## Specific Design Plan Locust Hill, Phase 2

## SDP-2504

SUBJECT: Specific Design Plan SDP-2504  
Type 2 Tree Conservation Plans TCP2-2025-0062  
Locust Hill – Phase 2

**Figure 1: Specific Design Plan**

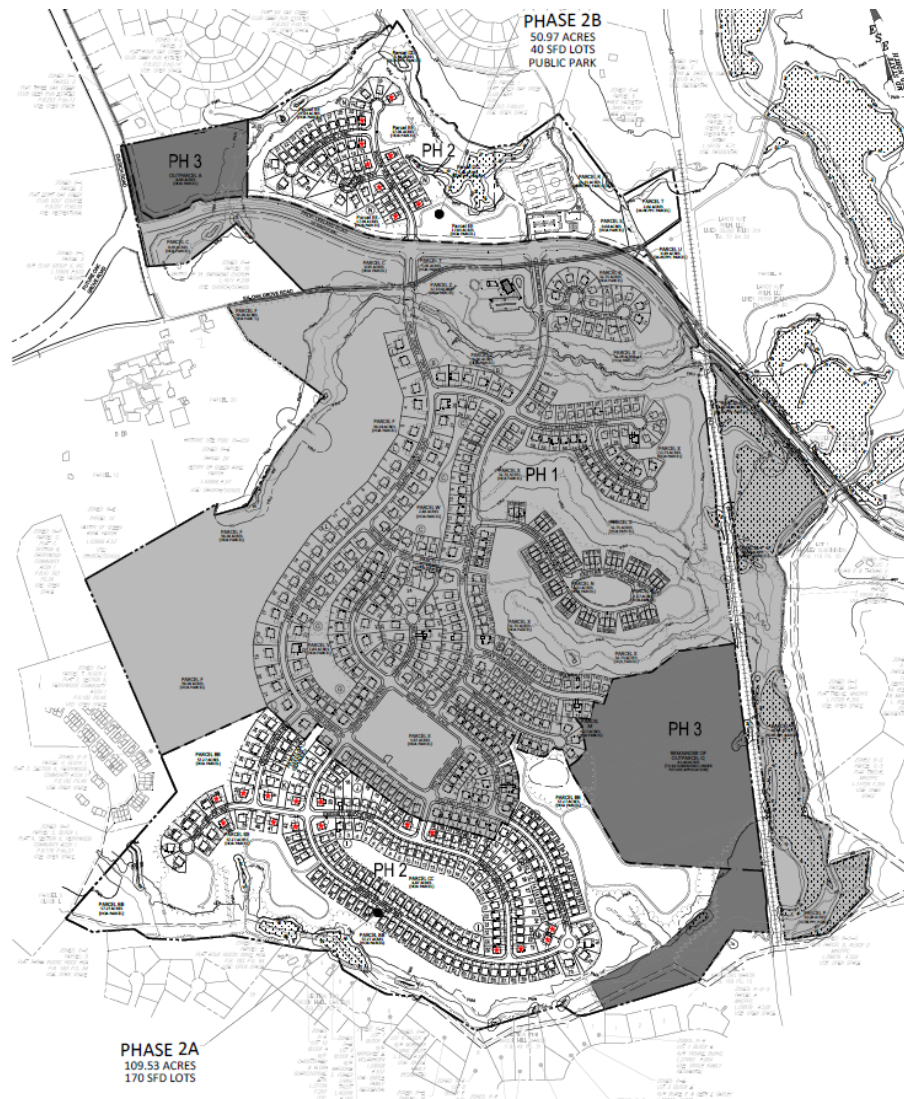
The subject SDP is for development of 210 single-family detached homes. With SDP-2101, the Planning Board approved 31 single-family detached home architectural models. Additional architectural models for single-family detached homes were subsequently added with approval of SDP-2101-01 and SDP-2101-02 by the Planning Director. Highly visible lots within Phase 2 are depicted on the coversheet of the plan set and staff find them consistent with the Phase 1 approval.

**Figure 2: Neighborhood Public Park Site Plan**

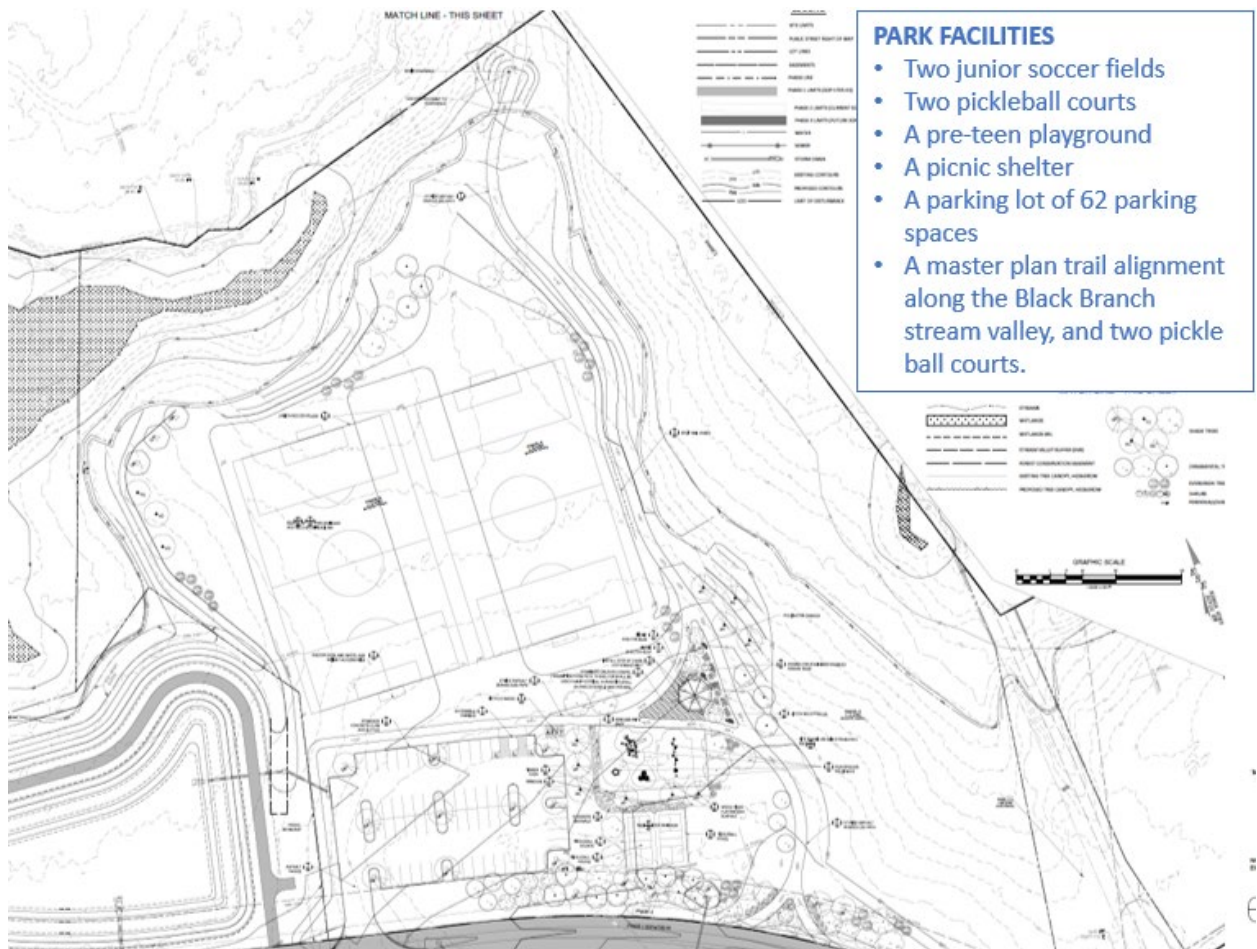
The detailed drawings for the public neighborhood park were submitted with the subject SDP, which are shown on Sheet 50 of the landscape plan. Park facilities include two junior soccer fields, a pre-teen playground, a picnic shelter of 600 square feet, a parking lot of 62 parking spaces, trails, and two pickle ball courts. Details of these facilities are shown on Sheets 51 through 54 of the landscape plan.

Sheet 50 of the landscape plan shows a 10-foot-wide shared-use path within the public neighborhood park (Parcel R), as a connection between the Black Branch trail and the Oak Creek development. The RFA shall be amended to reflect the recreation facilities and the trail alignments, which is conditioned herein. Six-foot-wide feeder trails and other internal connections are shown on the submitted REC-02, Overall Pedestrian and Cyclist Circulation Exhibit, and REC-03, Overall Recreation and Trails Exhibit, as approved with SDP-1705-02 (Phase 1) and the subject SDP (Phase 2). Trails details are included in SDP-1705-02 and the subject SDP to ensure dry passage. DPR staff have reviewed and approved the proposed trails within Phase 2.

DPR staff have reviewed and approved of park plan/details as required by the condition.
